Access Compliance Report

Public Rights-of-Way

(Curb Ramps)

Intersection ID: 28462	Main Street: WESTWINDS_CT	Cross Street: LAWING_SCHOOL_RD	Location: NE
ADA ID: 109DF7552D07	Ramp Type: Directional1	Initial Pass/Fail: Pass	Overall Compliance: No
Codes/Mitigation Info/Possible Solution		Field Measurements/Component Compliance	
Severity Score: 7.5

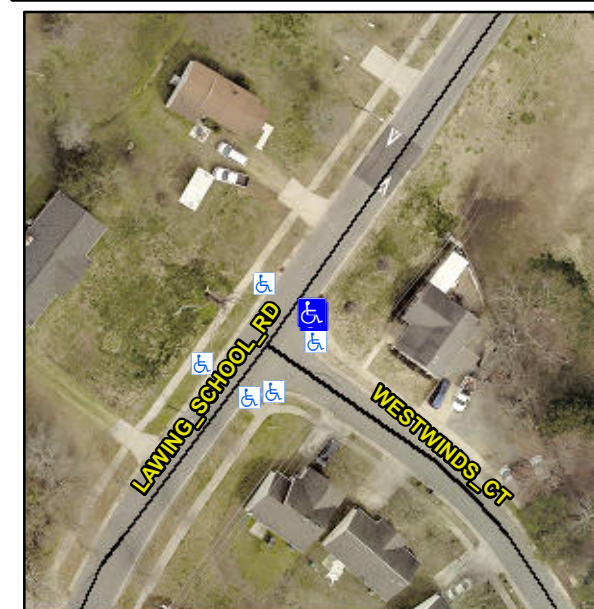
**Remove & Replace Entire Ramp.
Remove & Replace Gutter.**

**Not Found, R304.2.2-Perp, R304.3.2-
Para, R305.1.4, R305.2, R304.5.4**
